STAFF REPORT

ITEM: Wyndham Village Preliminary Plat and Zoning Map Amendment

Re: Wyndham Village Preliminary Plan Review

WYNDHAM VILLAGE
 LAKE ELMO, MN
 PRELIMINARY LANDSCAPE PLAN

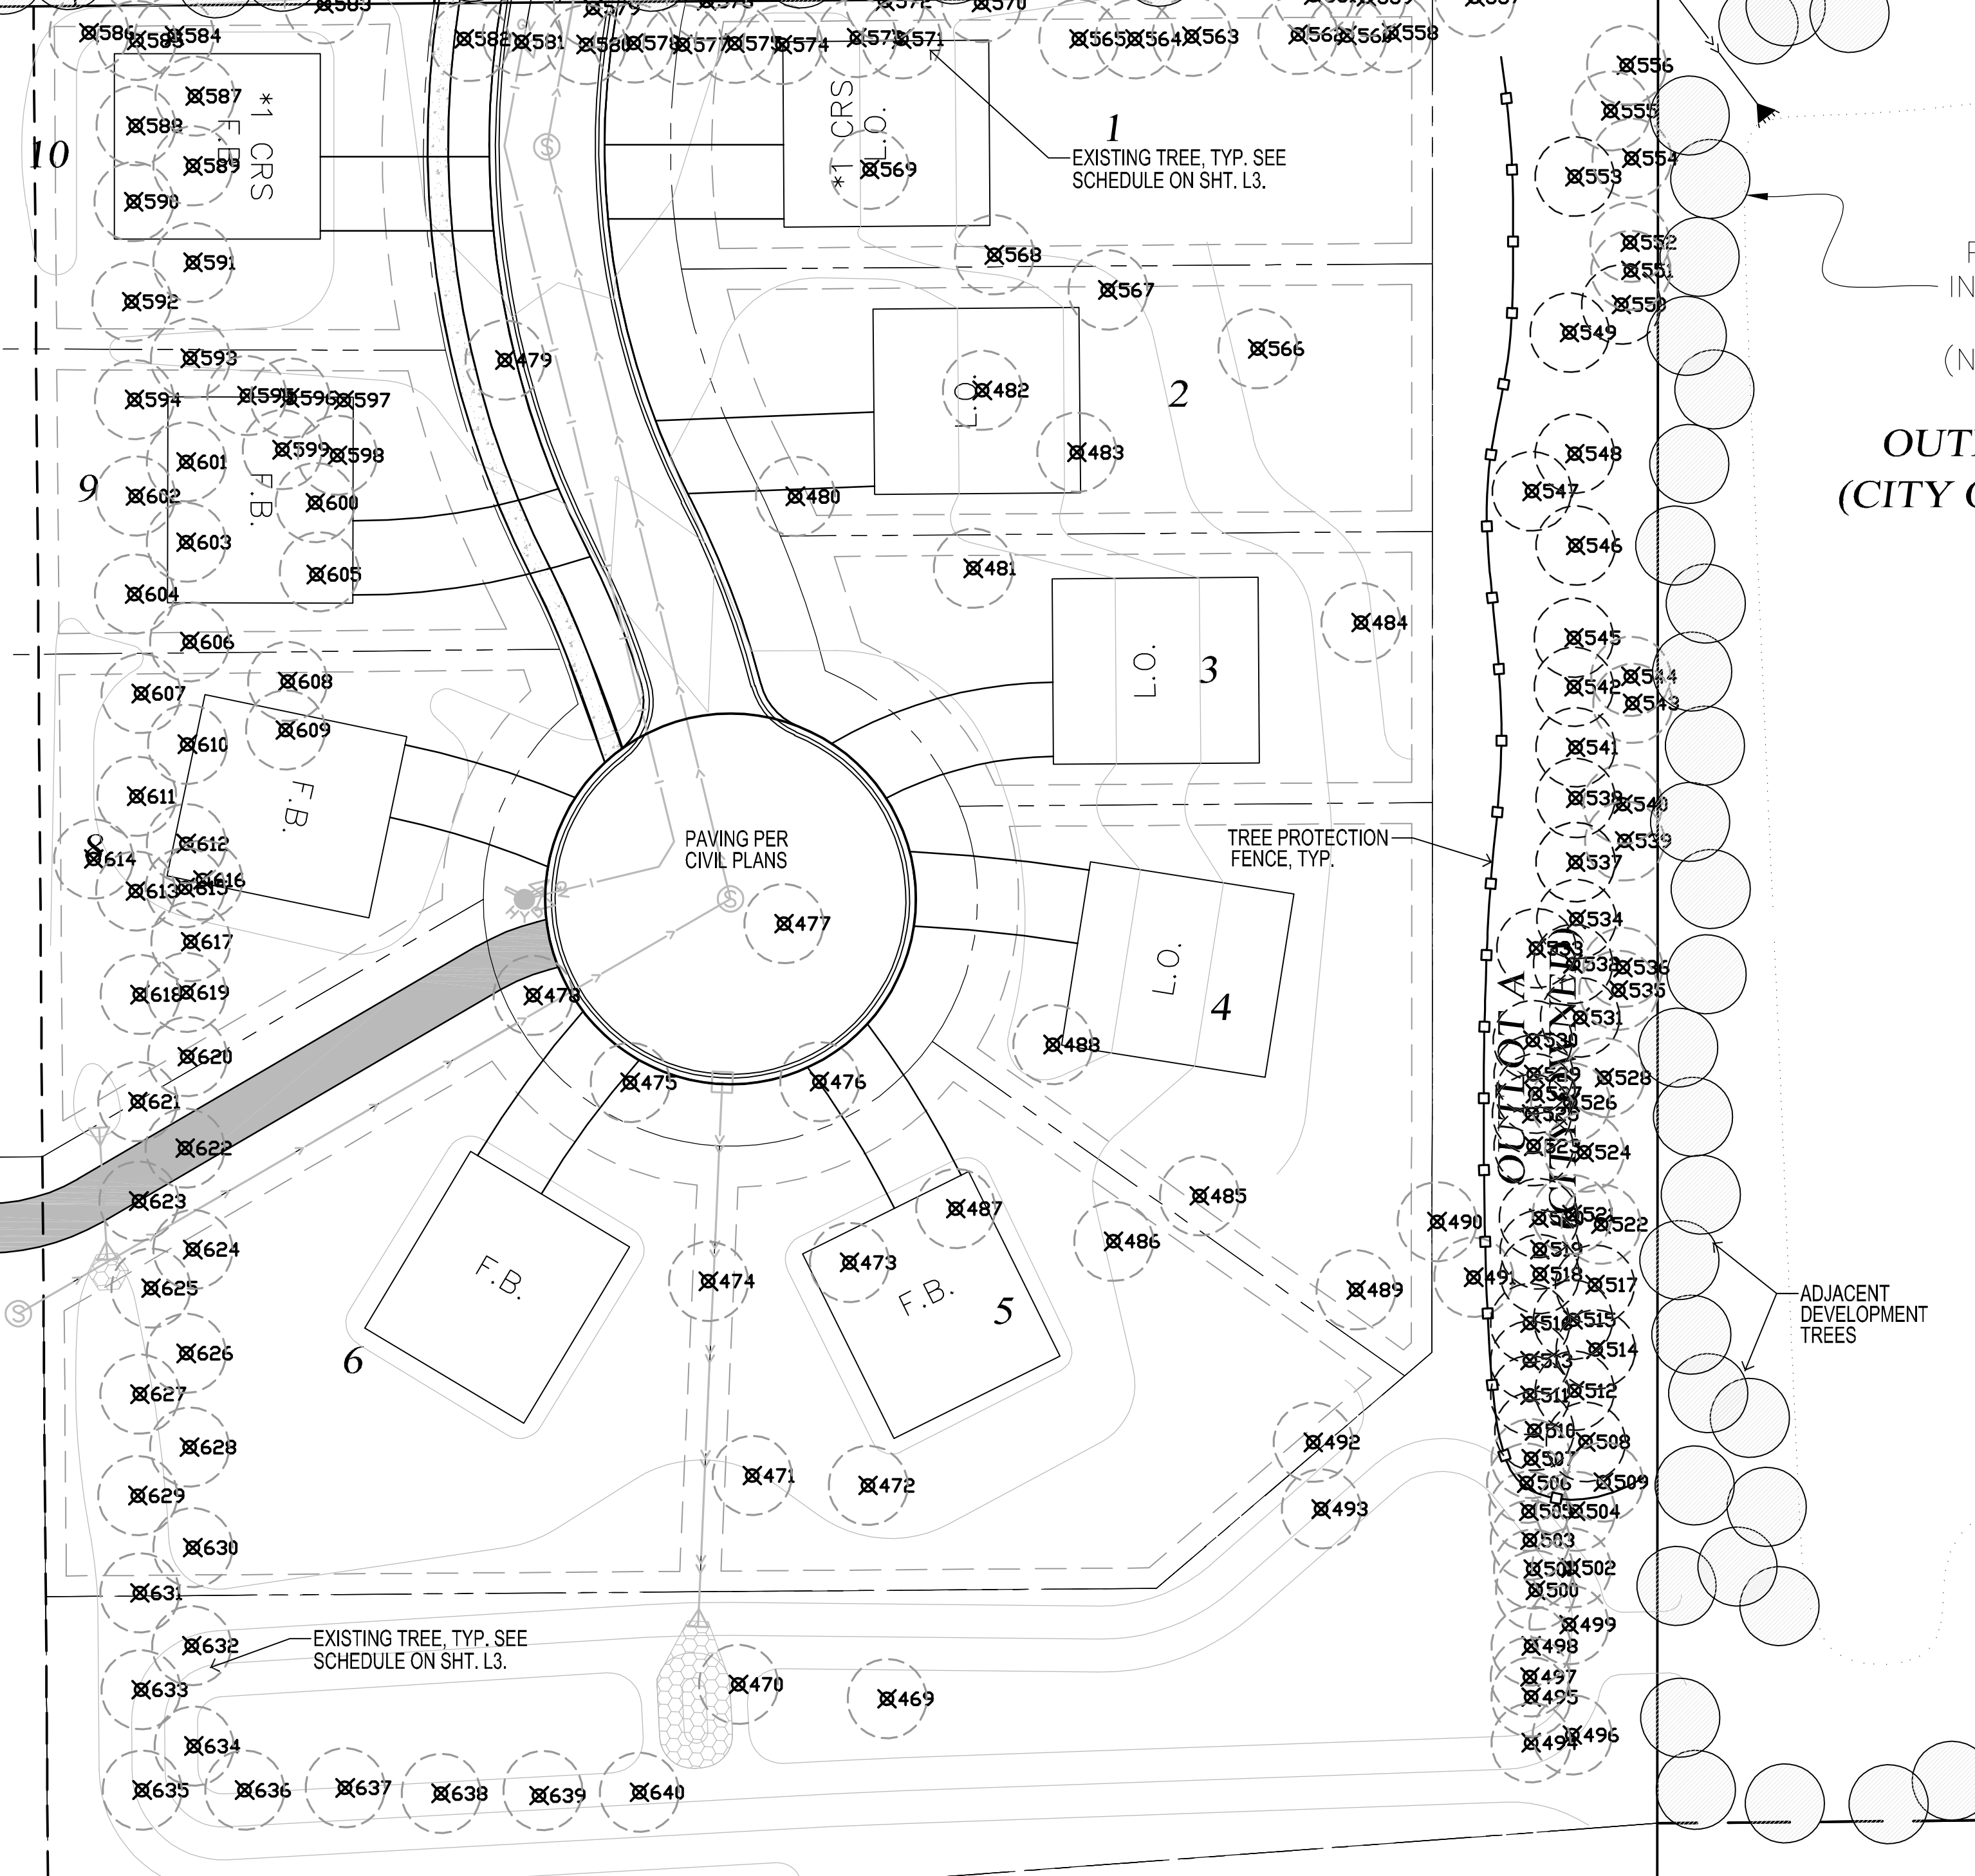
Landscape Plans. The City's landscape architect has reviewed the landscape plans, but due to insufficient information provided by the applicant has not yet completed review. Approval is contingent upon approved landscape and tree preservation plans being approved by the City's Landscape Architect.

- This review does not cover the Landscape Plan or Irrigation Plan. Plan review to be completed by other City representatives.
- The Landscape Plans must be revised to accommodate maintenance access to all storm water BMPs. Grades along pond access cannot exceeded 10% and must be a minimum of 20 feet in width. Maintenance access from public right-of-ways must be shown on the Landscape Plans.

The Preliminary Landscape Plan appears to indicate that many existing trees will be relocated to a new location on the site. MAC requests that, if feasible, any new trees introduced to the site be of a non-fruit bearing species to minimize wildlife attractiveness. The City must also be aware that any trees planted in the vicinity of an approach to a runway may require removal or trimming (at the Owner's expense) at some future date if they grow to become an obstruction to the airspace of the Airport or compromise flight procedures.
